METROPOLITAN GOVERNMENT OF NASHVILLE AND DAVIDSON COUNTY

STAFF RECOMMENDATION
105 South 11th Street
May 21, 2014

Application: Demolition—principle building; New construction—infill
District: Lockeland Springs-East End Neighborhood Conservation Zoning Overlay
Council District: 06
Map and Parcel Number: 08309018100
Applicant: Remick Moore
Project Lead: Melissa Baldock, melissa.baldock@nashville.gov

<p>Description of Project: The application is to demolish a non-contributing commercial structure and to construct a new one-story commercial structure.</p> <p>Recommendation Summary: Staff recommends approval of the demolition and infill with the condition that staff approve a brick sample and the window and door selections prior to purchase and installation of these materials. With this condition, staff finds that the project meets Sections II.B. and IV.B. of the <i>Lockeland Springs-East End Neighborhood Conservation District: Handbook and Design Guidelines</i>.</p>	<p>Attachments A: Photographs B: Site Plan C: Elevations</p>
---	--

Figure 1. 105 South 11th Street.

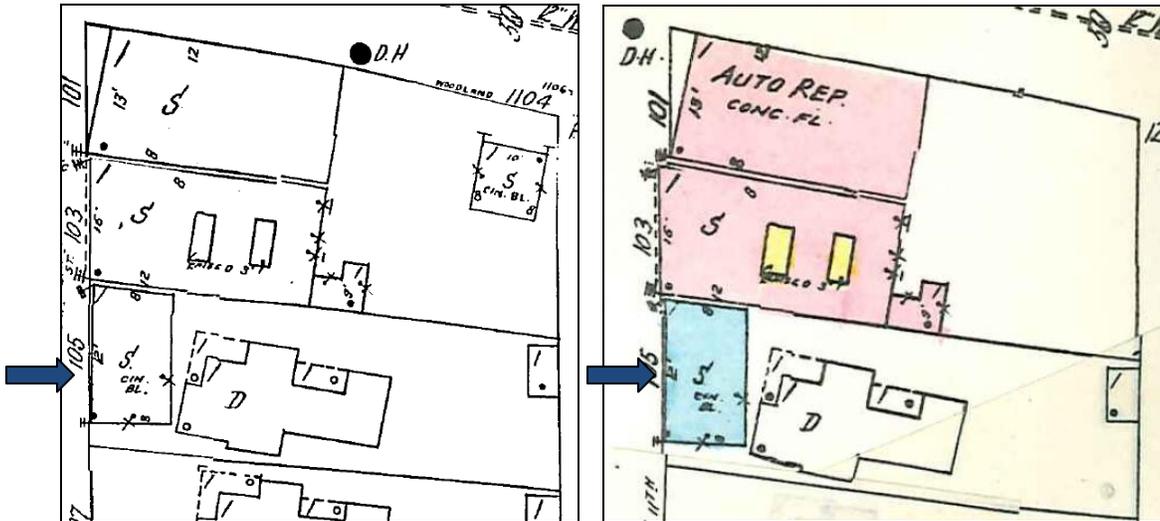
Background: 105 South 11th Street is a one-story commercial structure constructed c. 1946 (Figure 1). The structure does not contribute to the historic character of the Lockeland Springs-East End Neighborhood Conservation Zoning Overlay. The new development will also have to be reviewed by M.D.H.A.

1 SITE PLAN
 1/16" = 1'

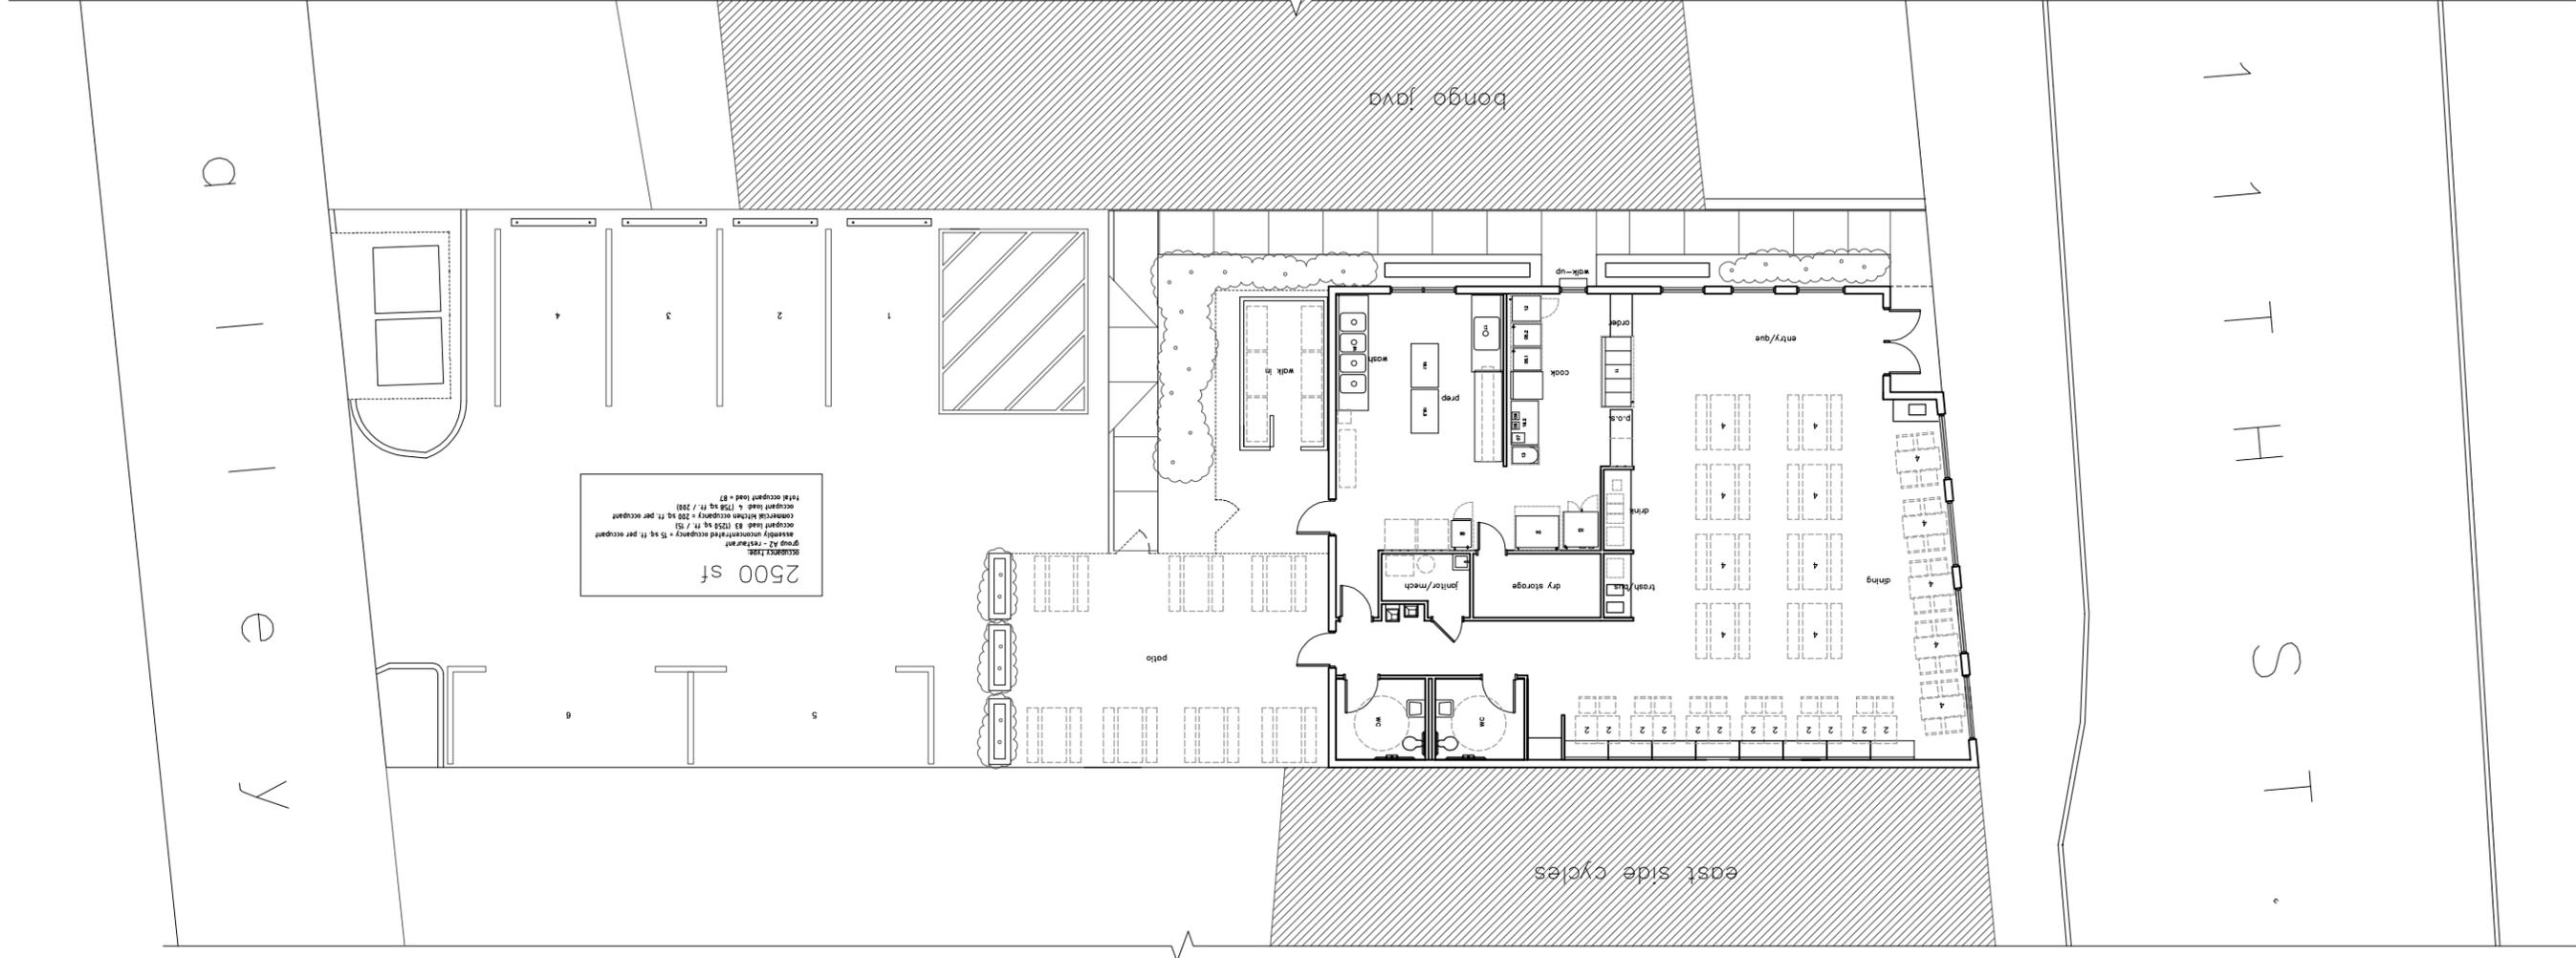
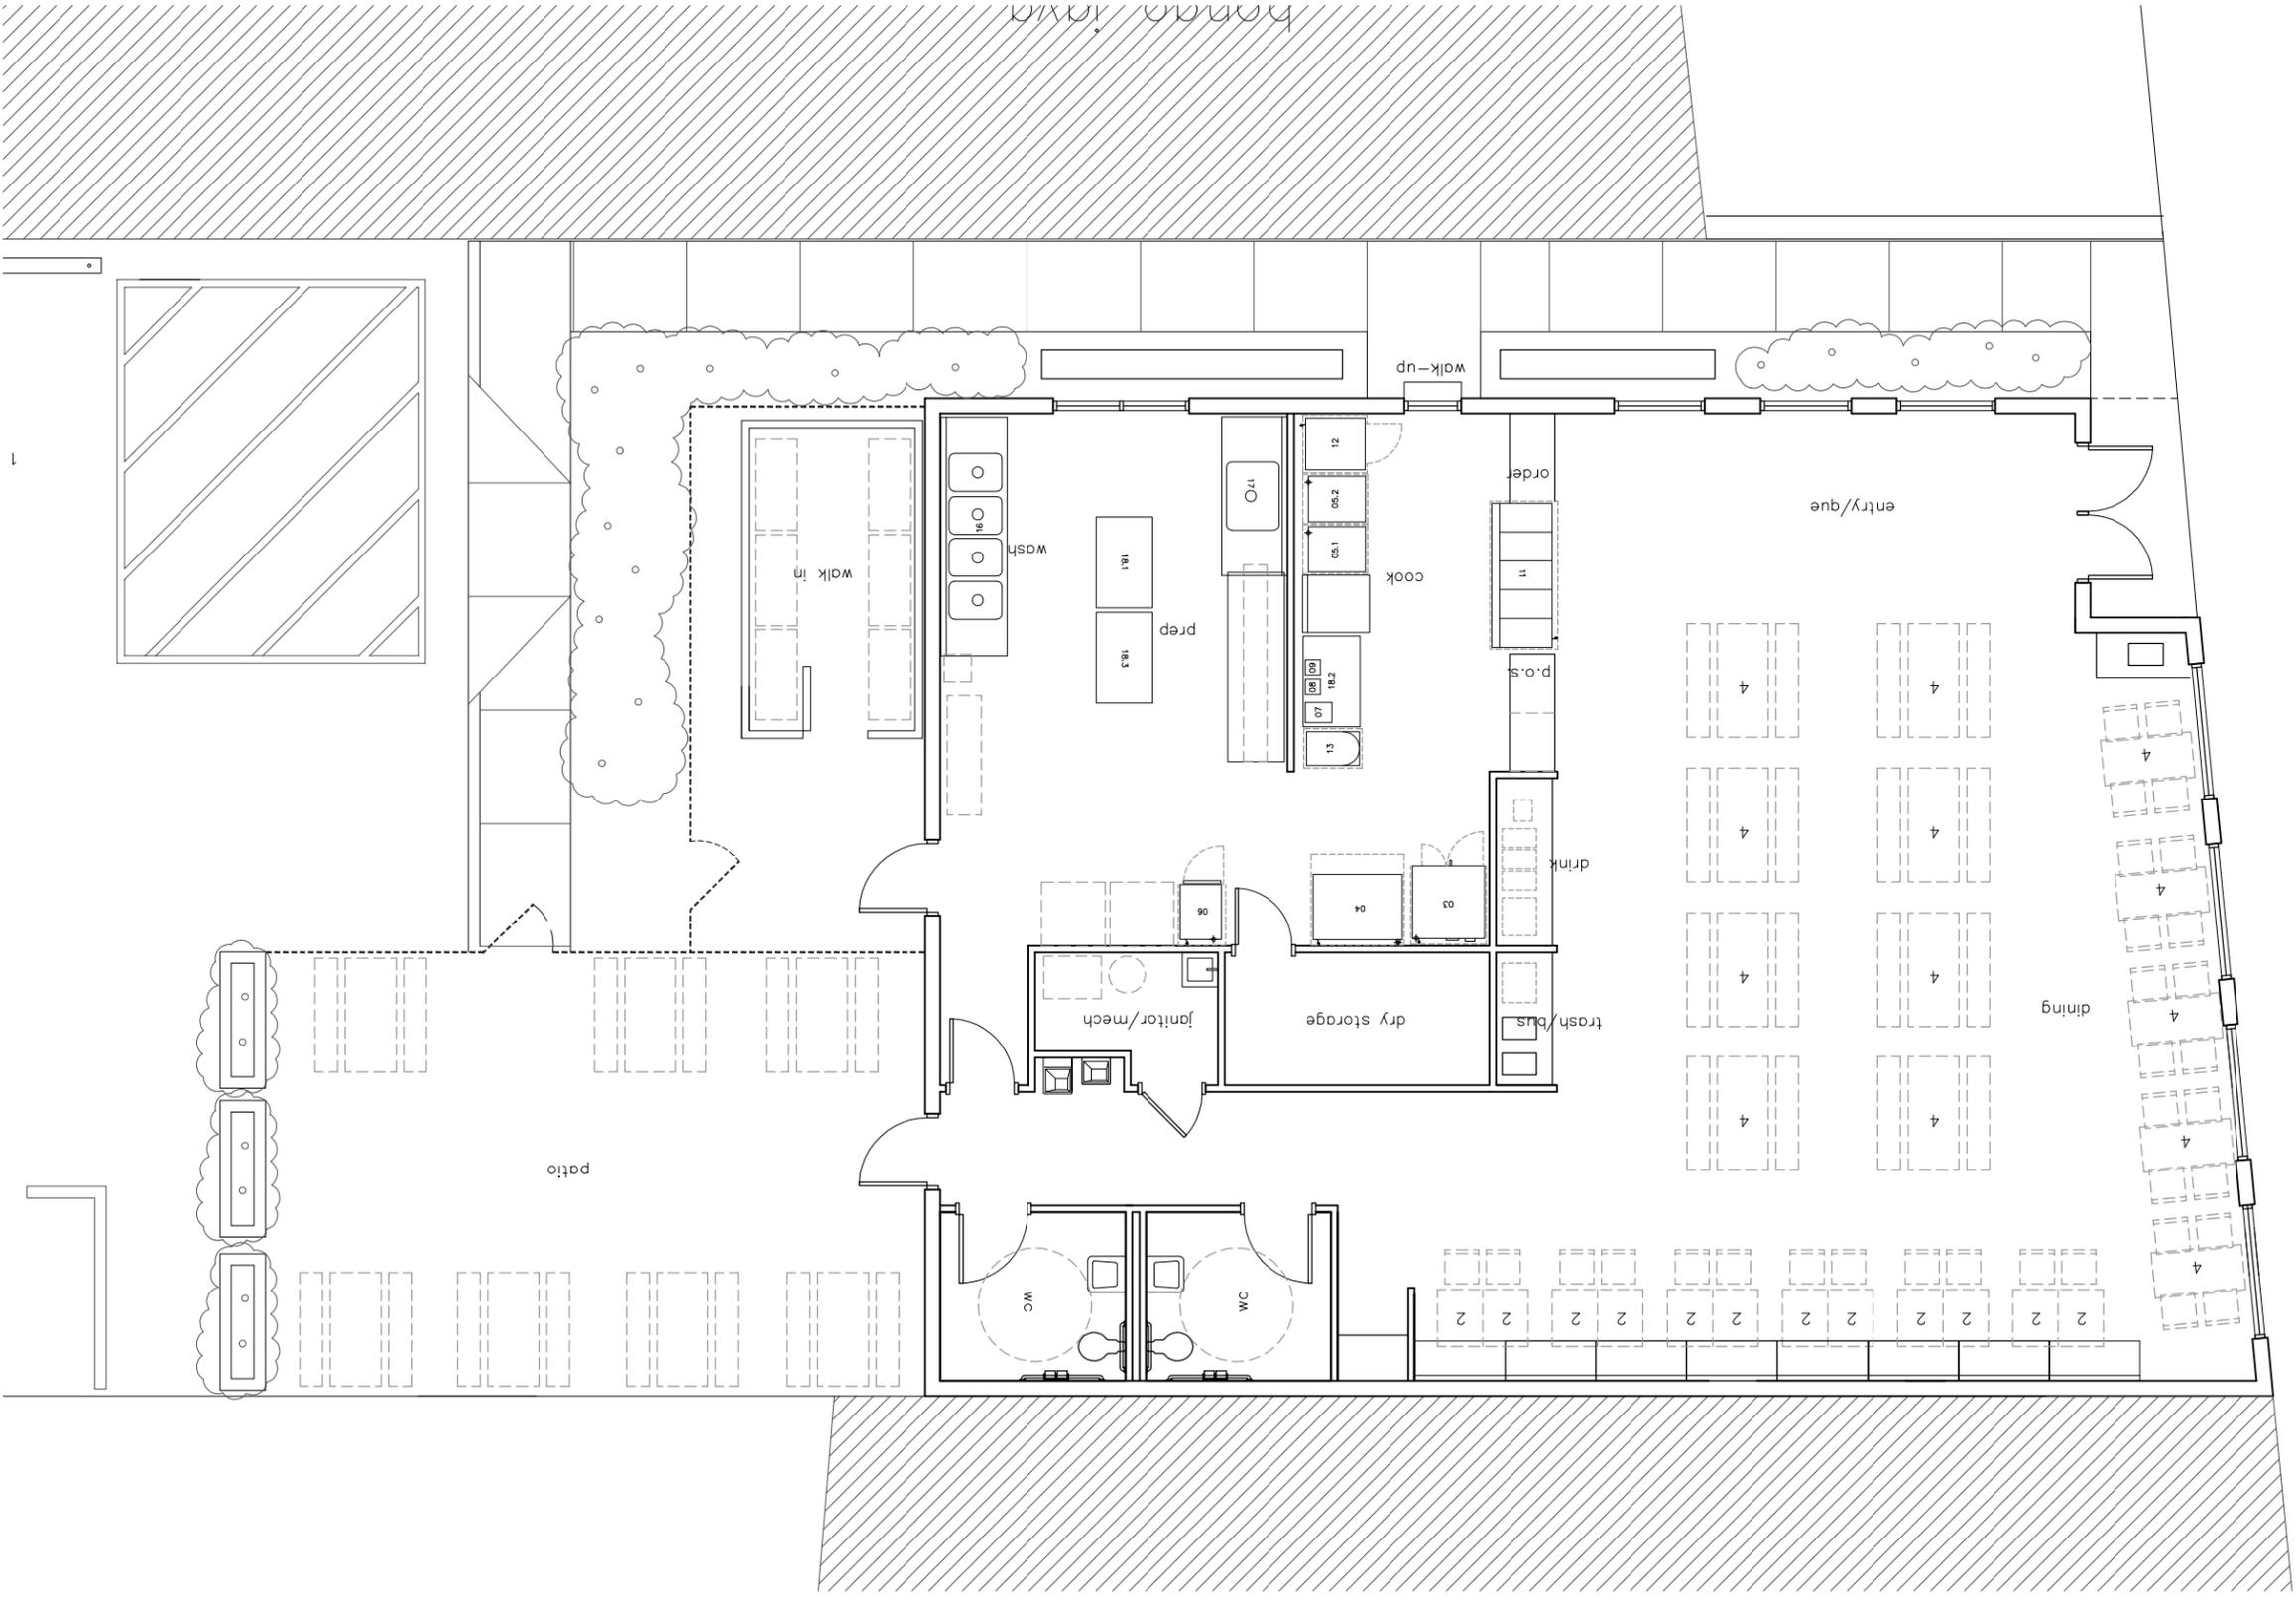
Appurtenances & Utilities: Parking for the site will be provided in the rear of the lot, accessed via the alley, which is appropriate (Figure 7). On the south façade will be two benches on either side of the walk-up take-out window. On the rear, there will be a patio for outdoor dining. Also on the rear will be an exterior walk-in

cooler, which will not be visible behind the fence. The building's dumpsters will be located on the alley, which is appropriate. The location of the HVAC and other utility equipment was not specified. This review does not include exterior lighting or signage. Although a general area for signage is noted on the plans, no specific information about type, materials and dimensions was noted. Staff finds that the project's known appurtenances meet Section II.B.9. of the design guidelines.
